# Access Compliance Report

## Public Rights-of-Way

### (Curb Ramps)

Intersection ID: 47450	Main Street: PINTAIL_LANDING_LN	Cross Street: MALLARD_LANDING_RD	Location: NW
ADA ID: 8BA4CE0F4B6B	Ramp Type: Perp	Initial Pass/Fail: Fail	Overall Compliance: No
		Severity Score: 22.5

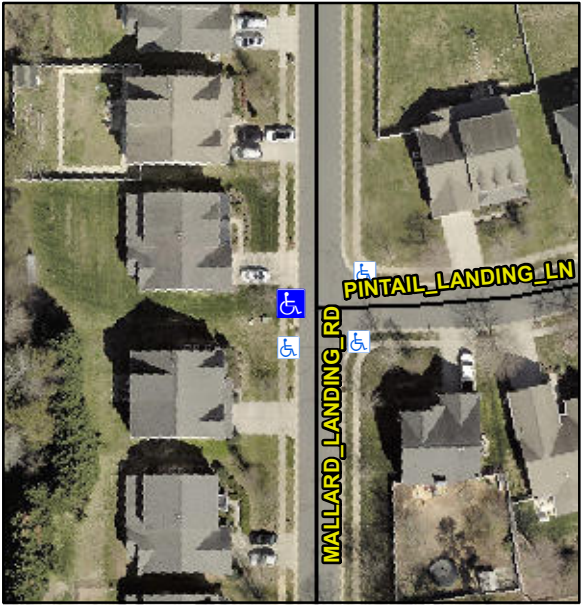
Codes/Mitigation Info/Possible Solution		Field Measurements/Component Compliance			
		Possible Solutions:	Compliance	Description	Data
		Remove & Replace Entire Ramp.	N/A	Ramp Length (in)	47.5
<p>Surveyor Notes:</p> <p>N/A</p> <p>PROW/ADA:</p> <p>Not Found, R304.5.1, R304.2.2</p>			No	Ramp Width (in)	47.0
			N/A	Flare Type LT	N/A
			N/A	Flare Slope LT (%)	N/A
			N/A	Flare Traversable LT?	N/A
			N/A	Landing Length (in)	N/A
			N/A	Landing Width (in)	N/A
			N/A	Landing Slope (%)	N/A
			N/A	Landing X Slope (%)	N/A
			N/A	Landing Curb? (Y/N)	N/A
			N/A	Shared Landing?	N/A
			N/A	Gutter Ponding?	N/A
			N/A	Gutter Lip Ht (in)	N/A
			N/A	Painted X Walk1?	No
				X Walk 1 Direction	To NE
			N/A	X Walk 1 Width (in)	N/A
				X Walk 1 Slope (%)	1.6
				X Walk 1 X Slope (%)	5.1
			N/A	Ramp inside XWalk1?	N/A
				Road Slope (%)	N/A
				Road X Slope (%)	N/A
			N/A	Any Obstructions?	N/A
				Obstruction Type	
Total Cost:		\$ 1850.00
